# ADDENDUM NO. 1

**April 29, 2022**

**NEW ADMINISTRATION CENTER, ALTERNATE EDUCATION AND  
RESOURCE CENTER AND RELATED WORK PROJECT  
Crown Point, IN 46307**

This Addendum forms a part of and modifies the Bidding Requirements, Contract Forms, Contract Conditions, the Specifications, and the Drawings dated April 15, 2022 by Gibraltar Design. Acknowledge receipt of the Addendum in the space provided on the Bid Form. Failure to do so may subject the Bidder to disqualification.

**FIRE PROTECTION ZONING PLAN / FIRE INSPECTORS TEST CONNECTION**

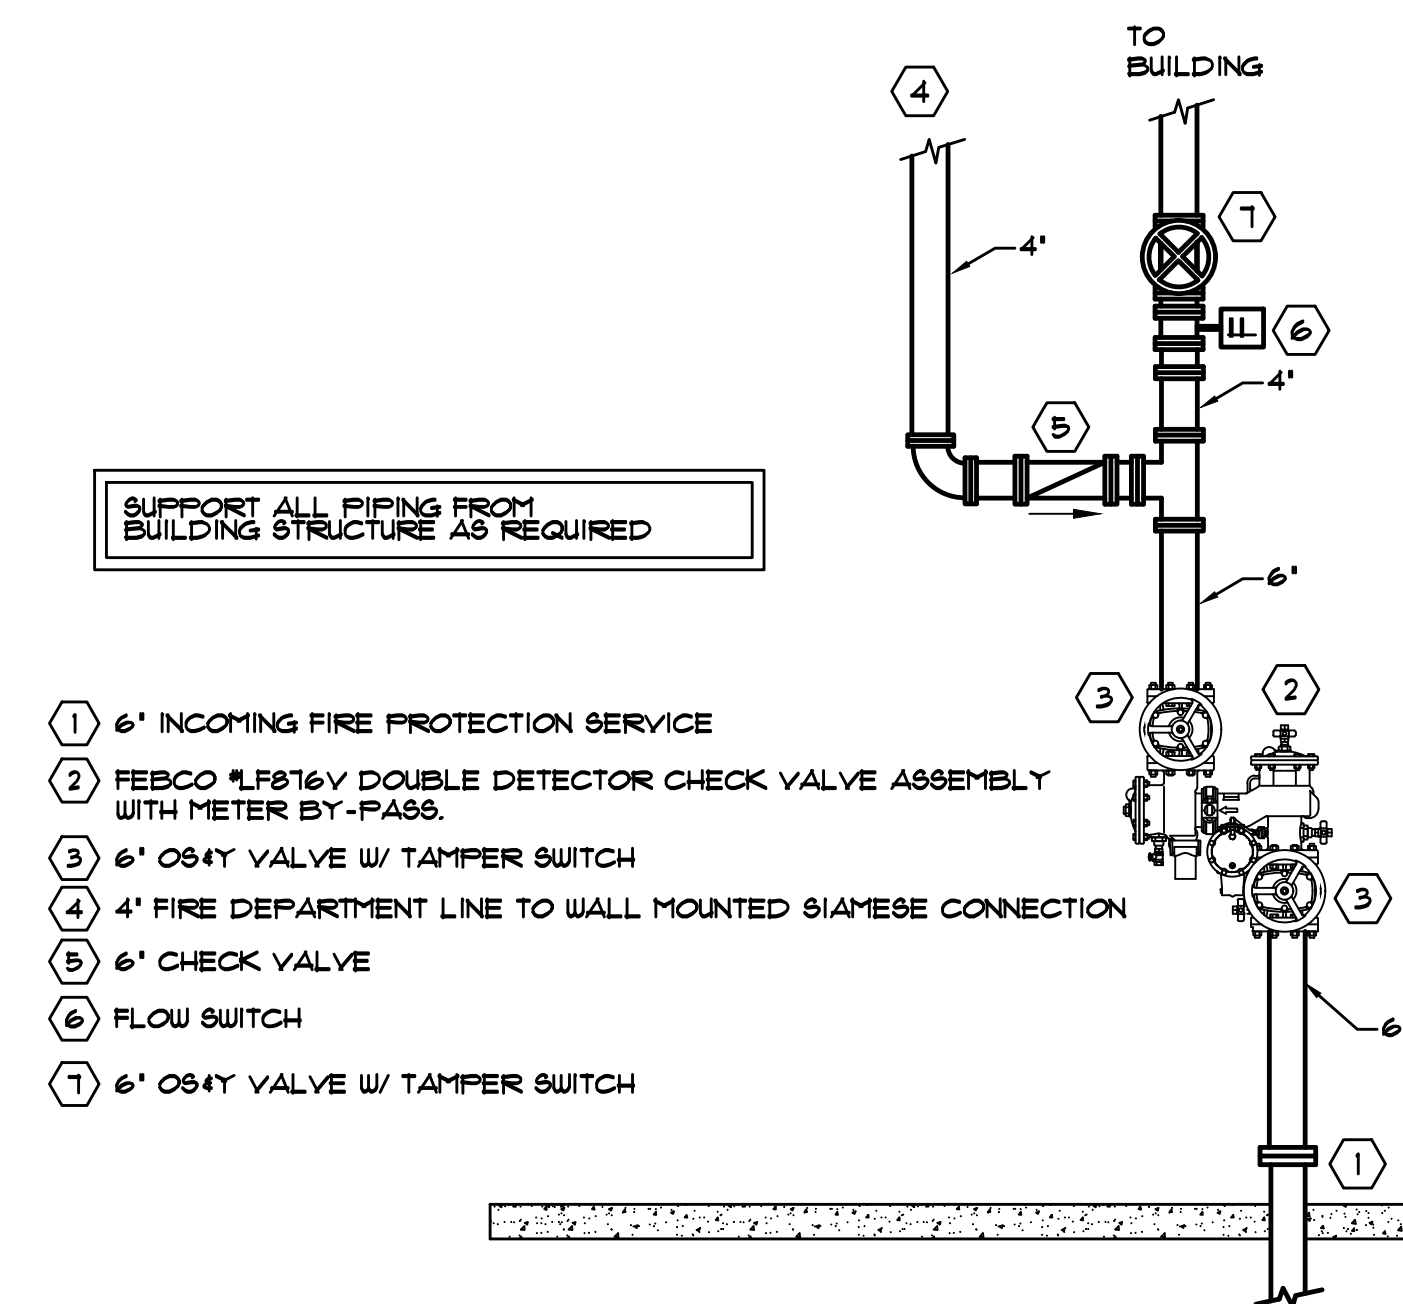
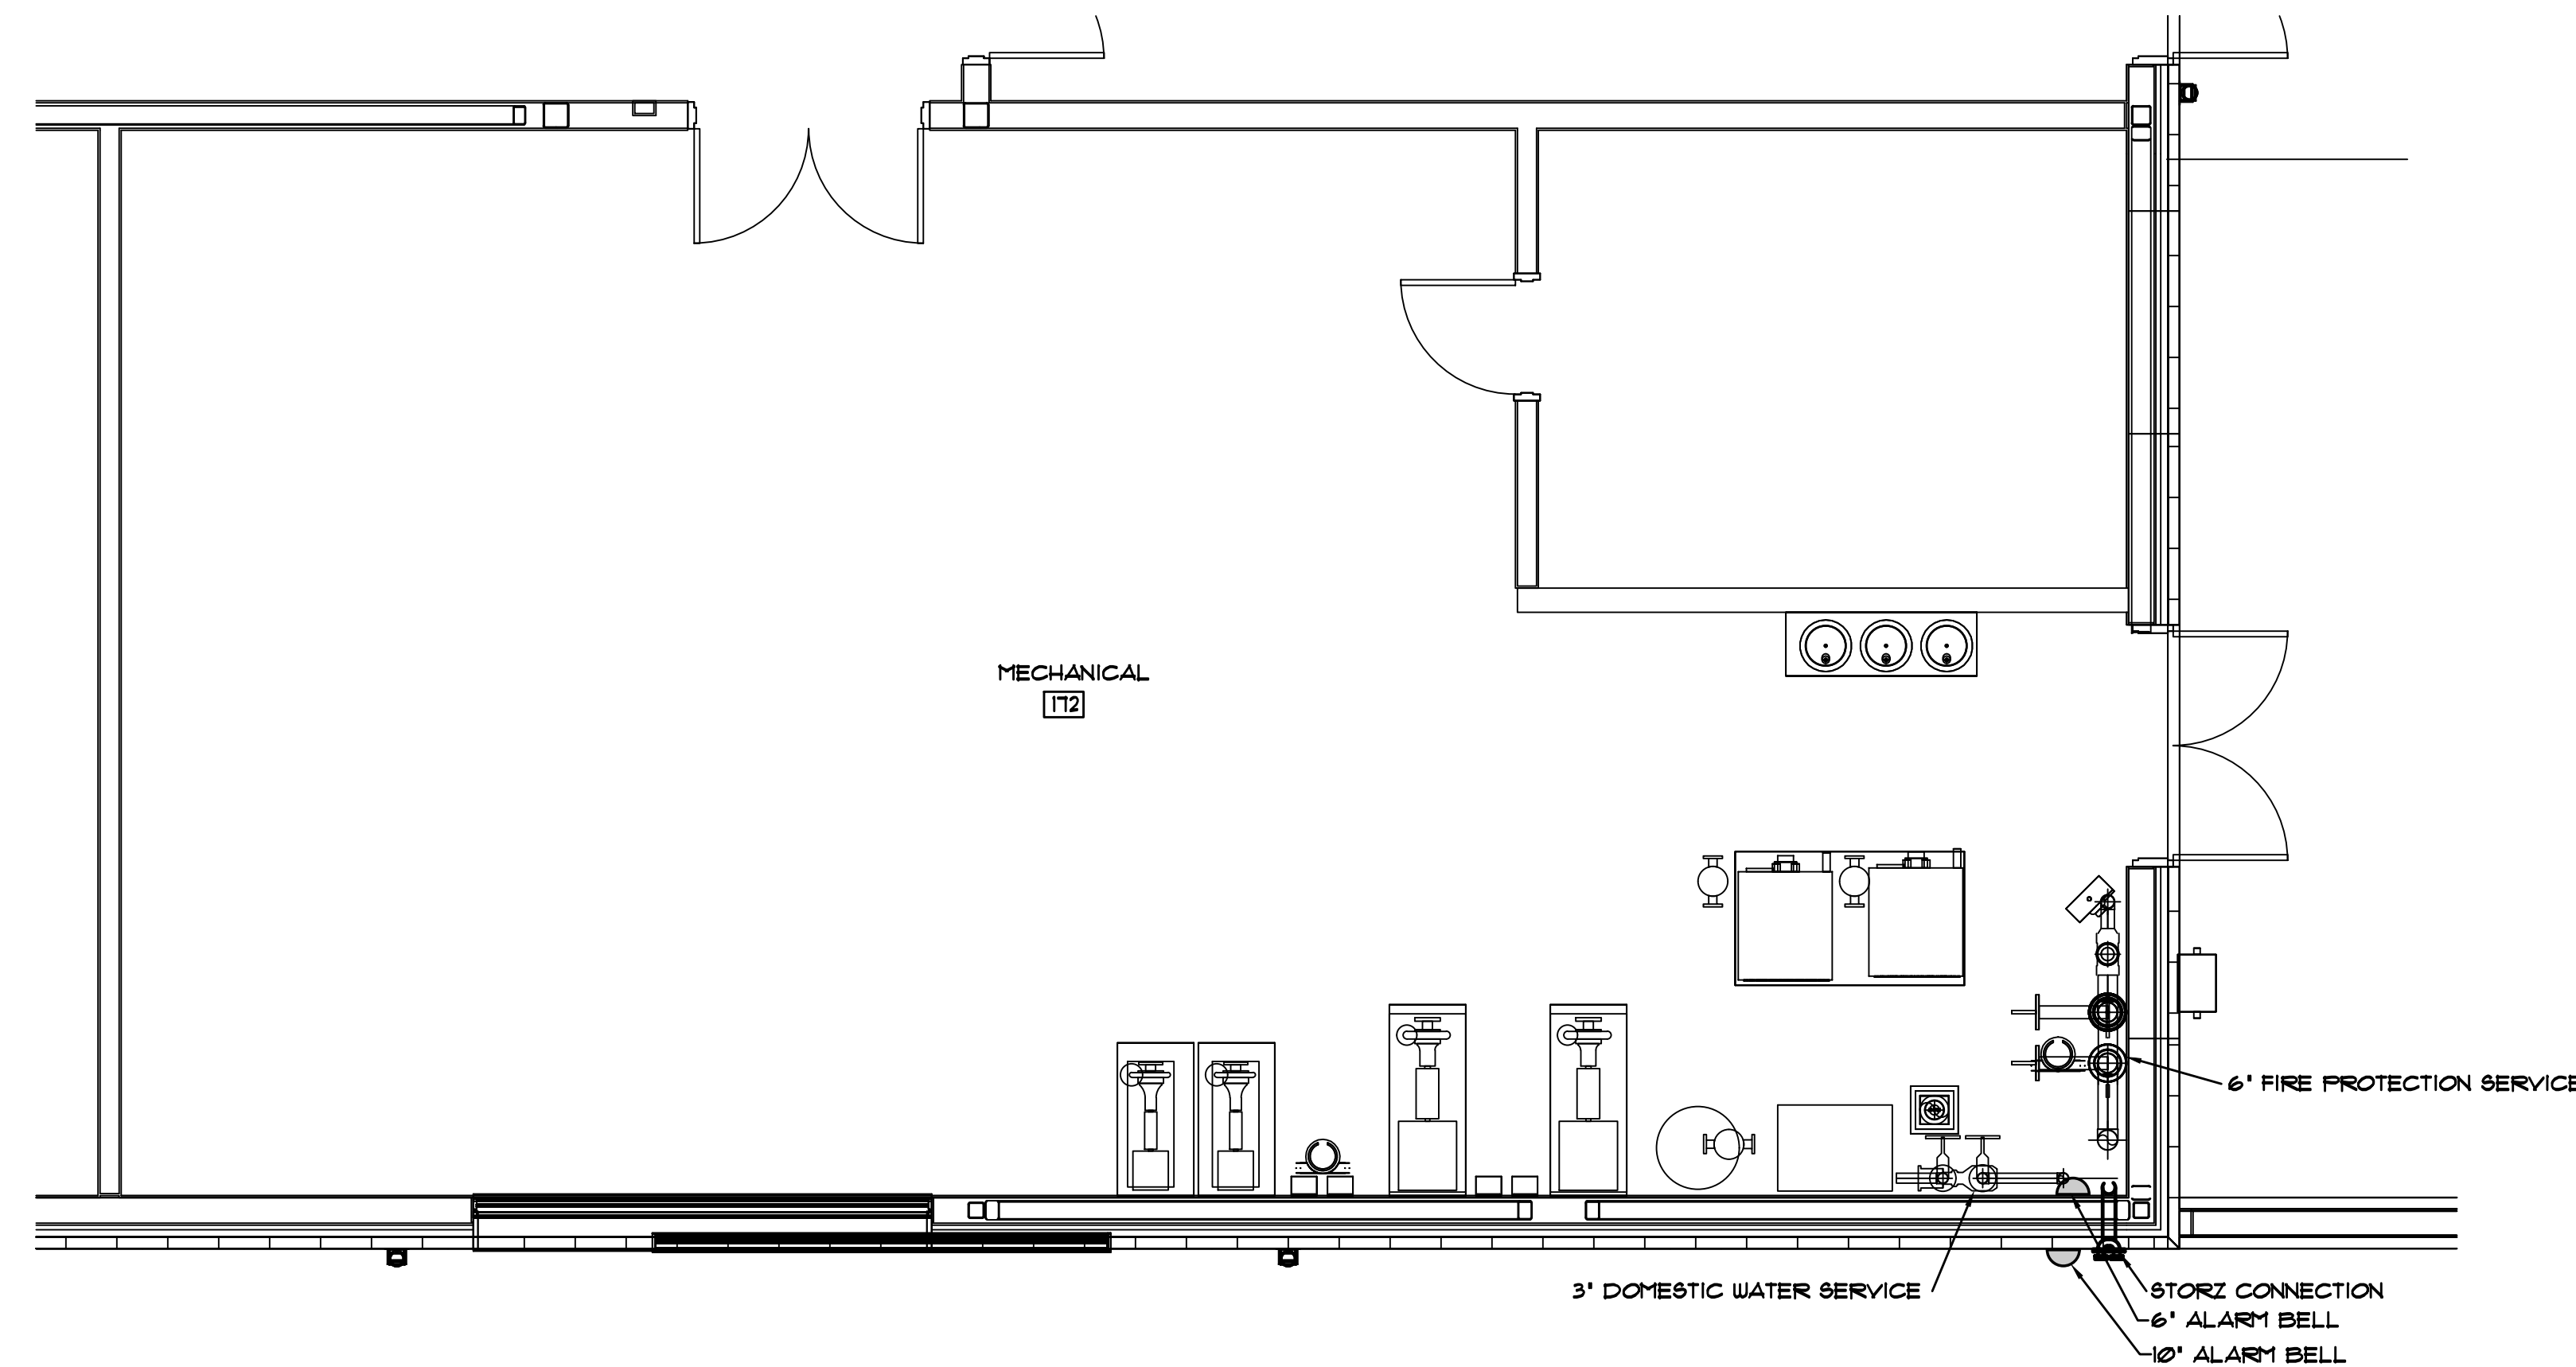
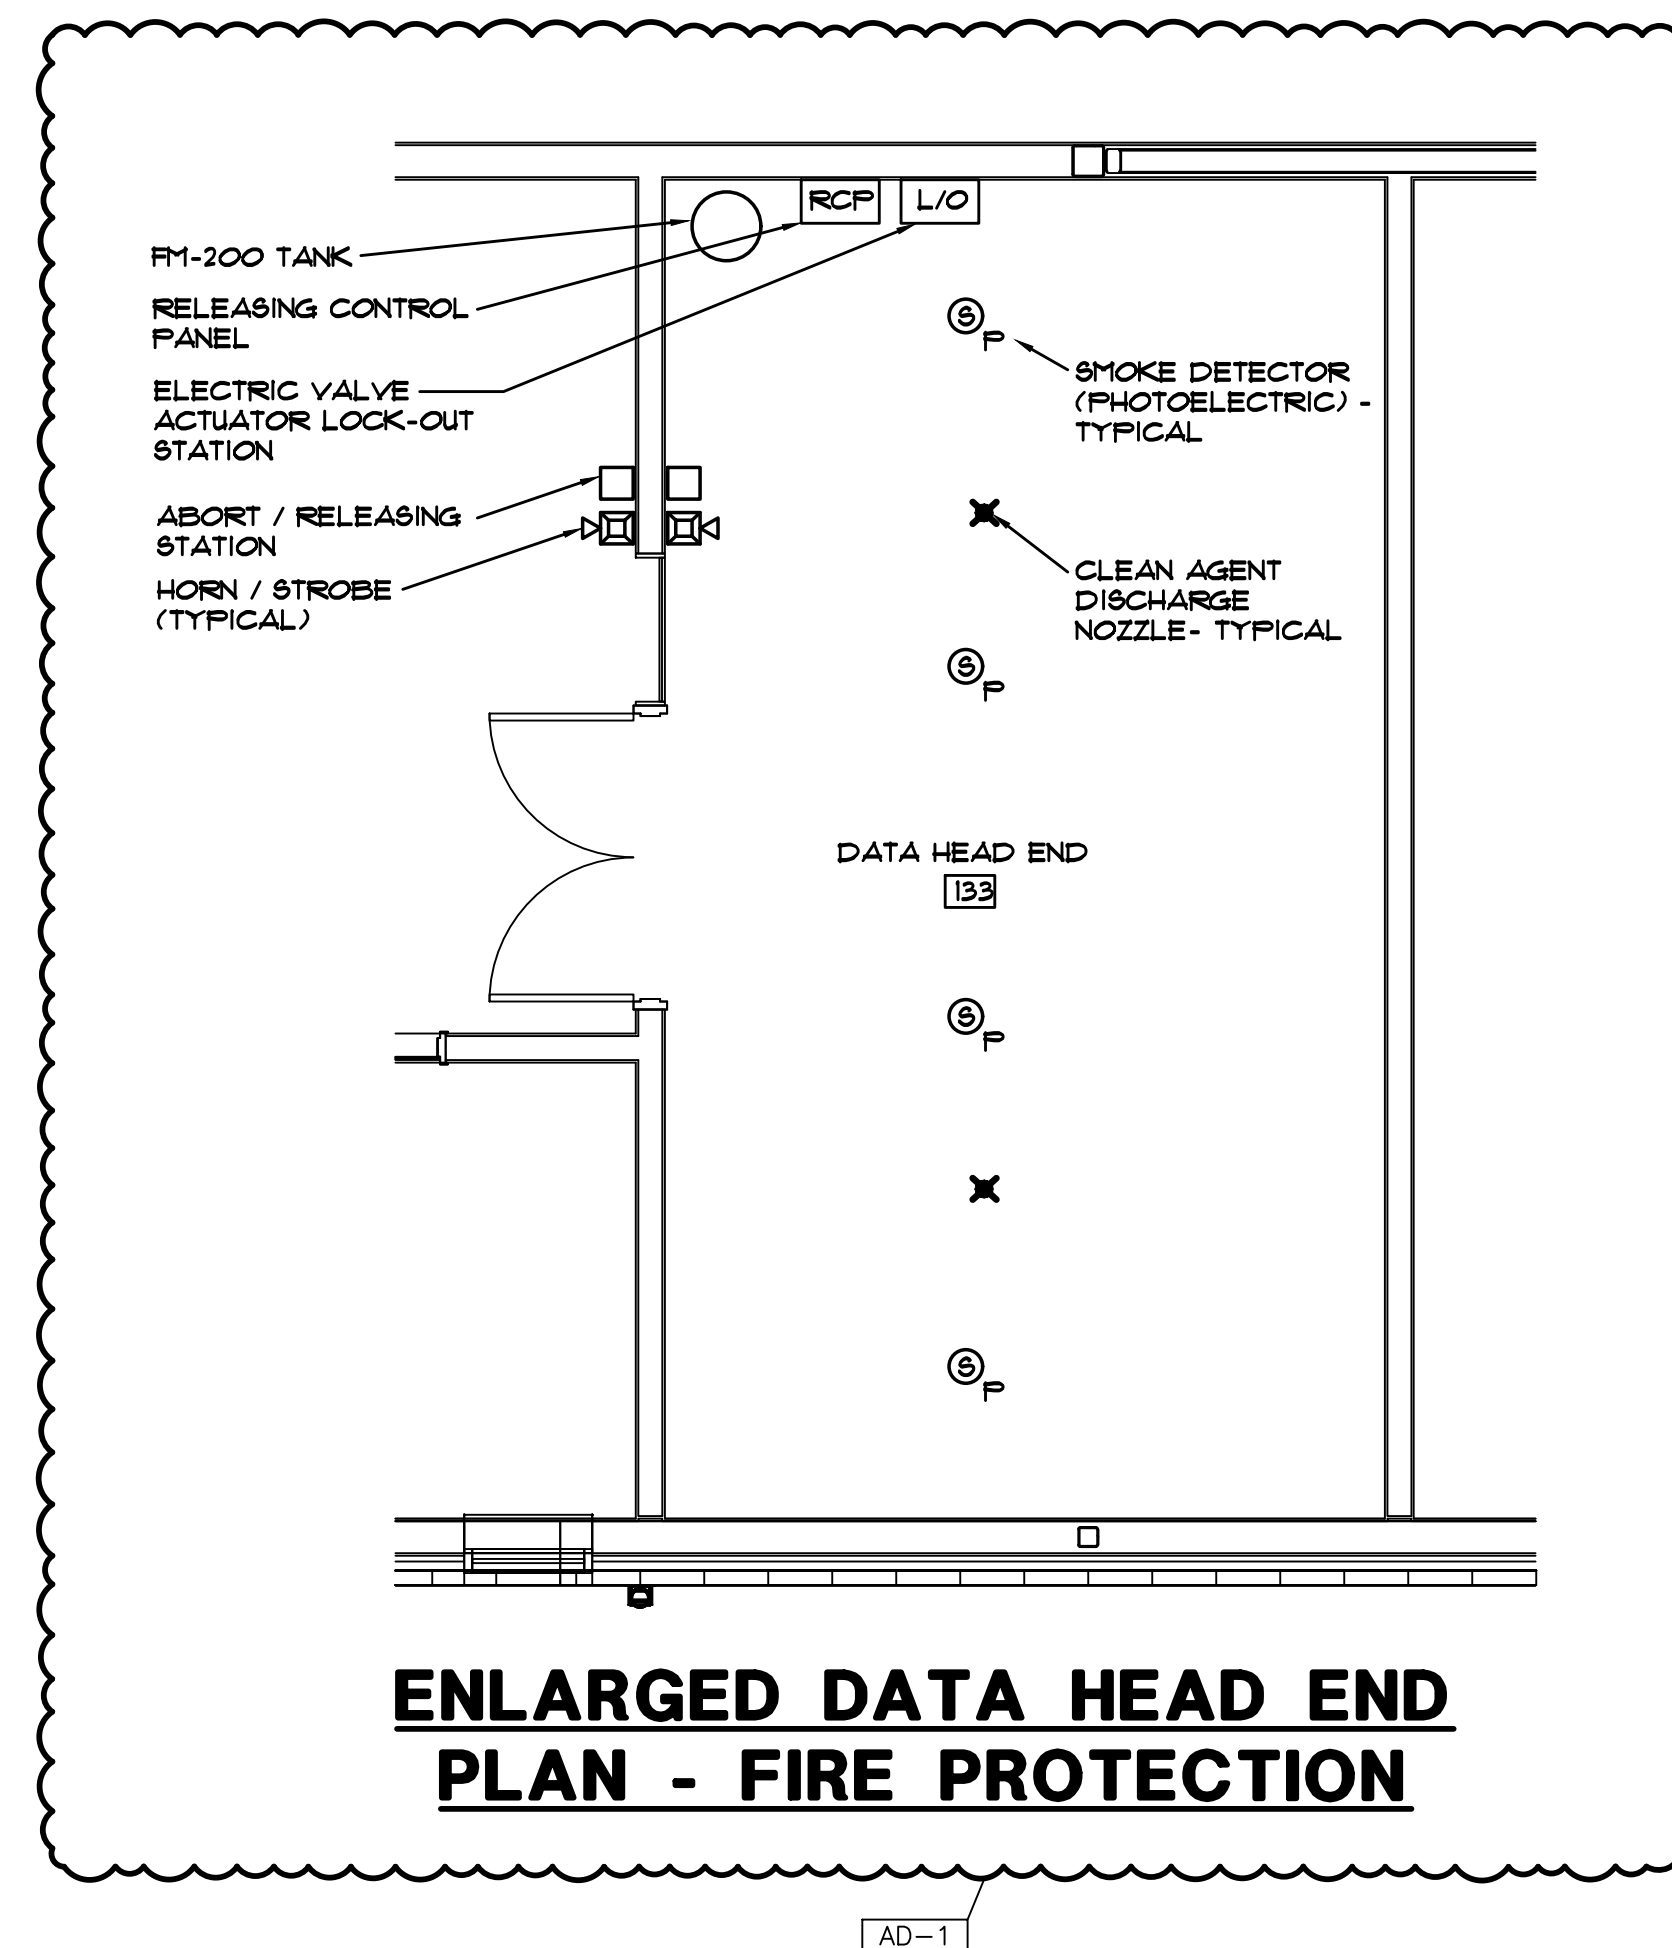
**11. Sheet FP-001**

- A. Refer to revised, full size drawing, included in this Addendum, for addition of "Enlarged Data Head End Plan – Fire Protection".
